Date: February 4, 2019

The **51060HIC125** humidity indicator card will now be marked with “Meets Type 1 requirements under J-STD-033D”. This will replace the previous wording, “Complies with IPC/JEDEC J-STD-033C”.

Old Artwork

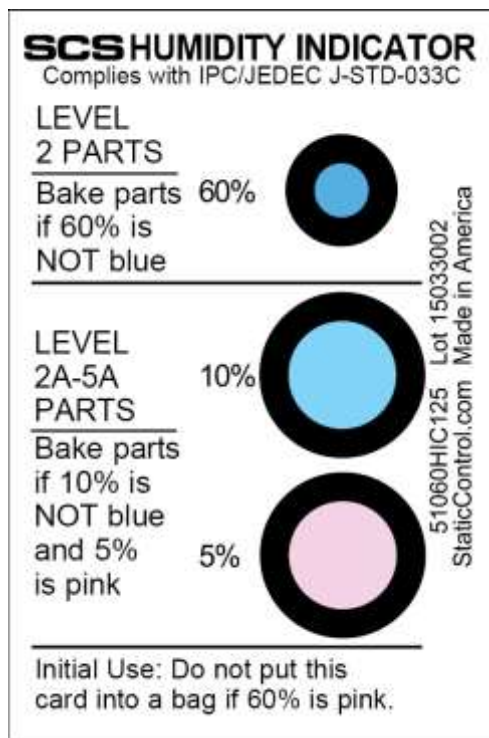
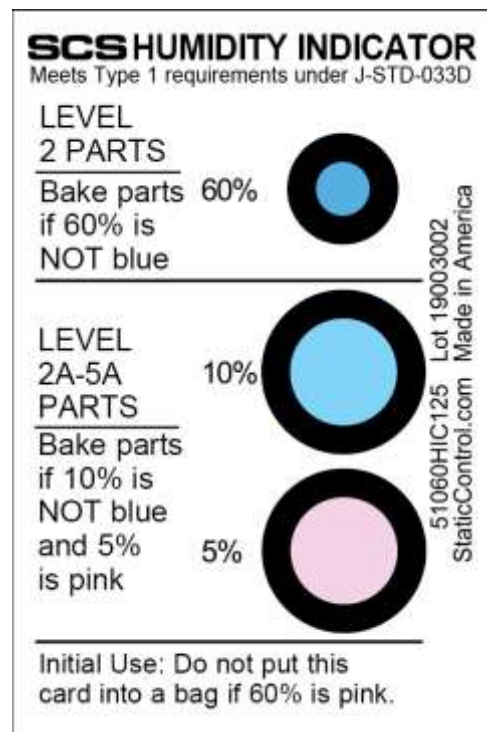
This is strictly a visual change to reflect compliance with Type 1 requirements for **IPC/J-STD-033D**. There has been no change to the fit, form or functionality of the product.

Key Dates/Traceability: Product marked with 1905002 date lot code, and date lot codes following (1905003, 1905004, etc.) will reflect these new changes.
